# Porsche Carrera Cup France 2022

## Note Technique 22/2022

### CONNECTEUR CAPTEUR DE PRESSION ADMISSION

## CONNECTOR FOR EXTERNAL AIRBOX PRESSURE SENSOR

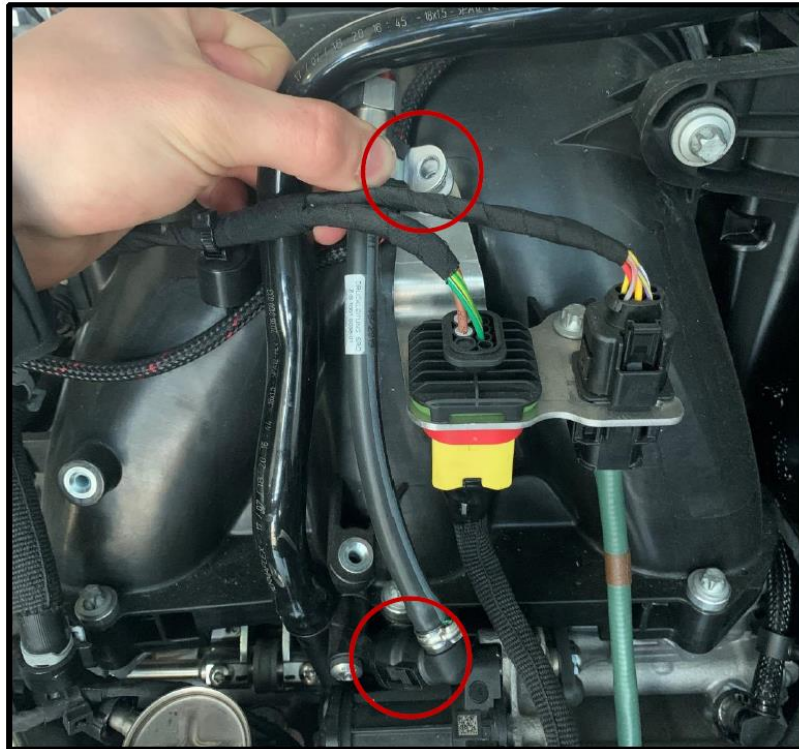
Porsche Motorsport informs that the intake pressure must only be measured via an external sensor fitted in place of the blanking plug on the right-hand side of the intake system above the electronic throttle control actuator. Replace the blanking plug with adapter 9F2131209 (parts list Pos. 1). Click the adapter into place and secure to the intake system as shown in the image below using the 'P-clip' clamp. Pressure sensors with an M10x1 thread can be used with the adapter.
